# CERTIFICATE OF APPROPRIATENESS PLACARD

Changes to previously-approved COA (COA-0173-2022),  
including: extend rear porch roofline

807 W South St

COA Minor Works Application Summary of Work for original approved COA-0173-2022

**BUILDING ELEVATION - WEST**  
COA  
2  
SK 1.3 1/8" = 1'-0"

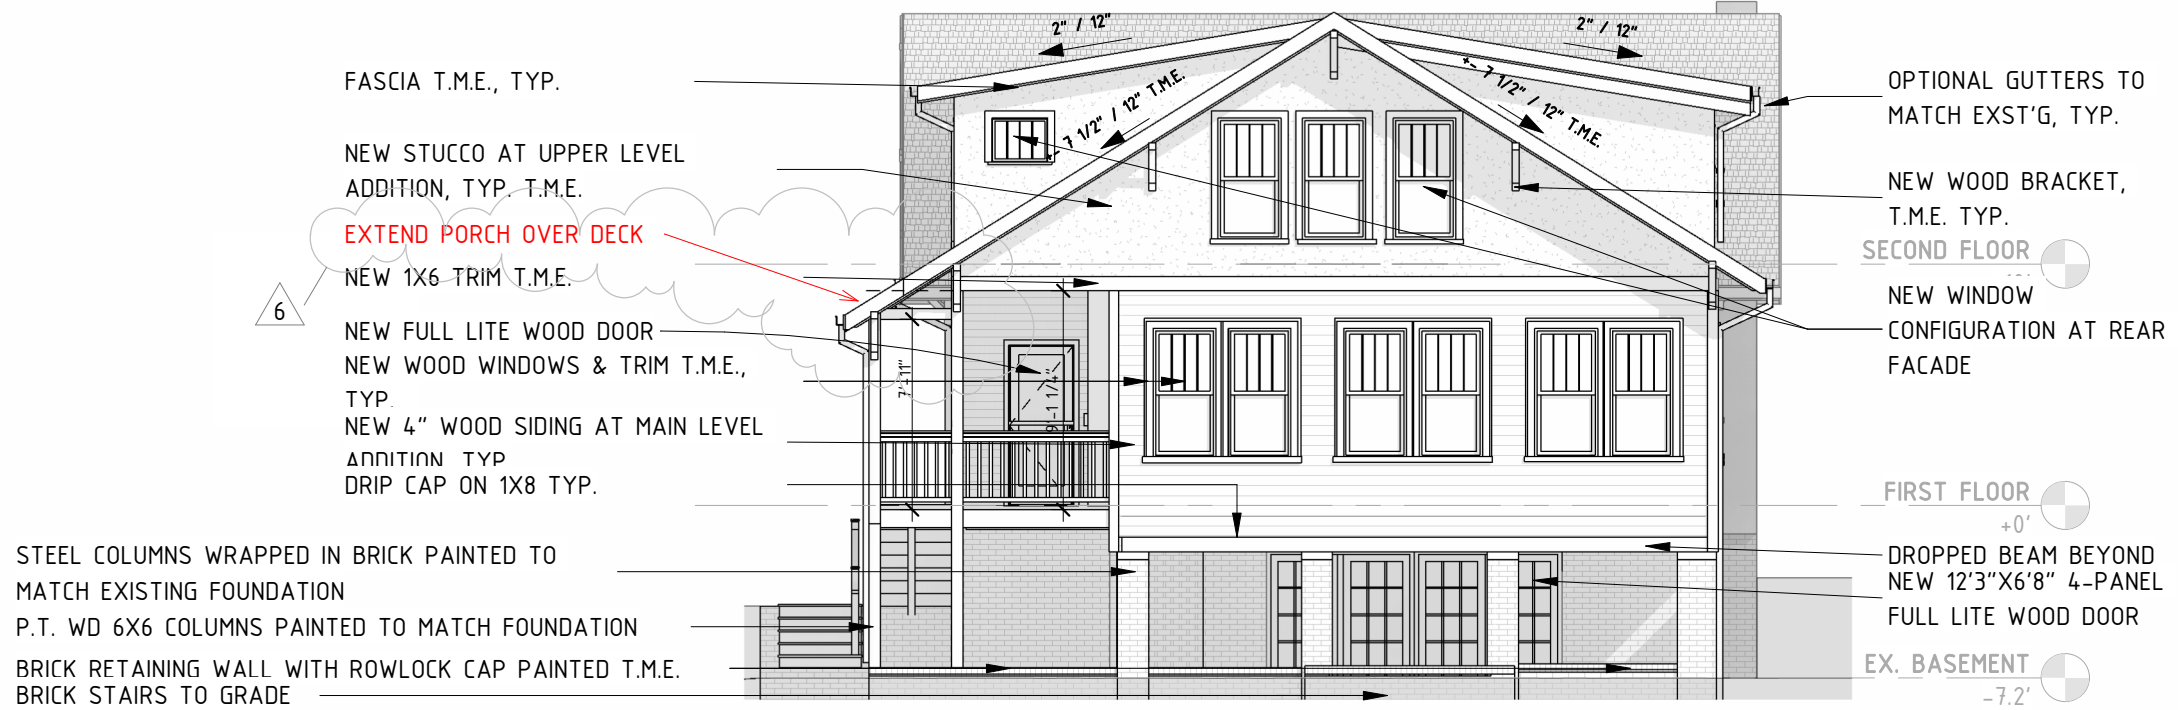
EXTEND PORCH OVER DECK

ADD WD. BRACKET AT NEW 6X6 P.T. COLUMN

EXTEND PORCH OVER DECK AT REAR

The changes to approved COA-0173-2022 are simply to extend the roof over the entire deck instead of a portion of the deck. There will be an two wood 6x6 columns to support the extended roof, and an additional bracket on the rear elevation to match the adjacent brackets. The roof slope will match the existing main roof slope.
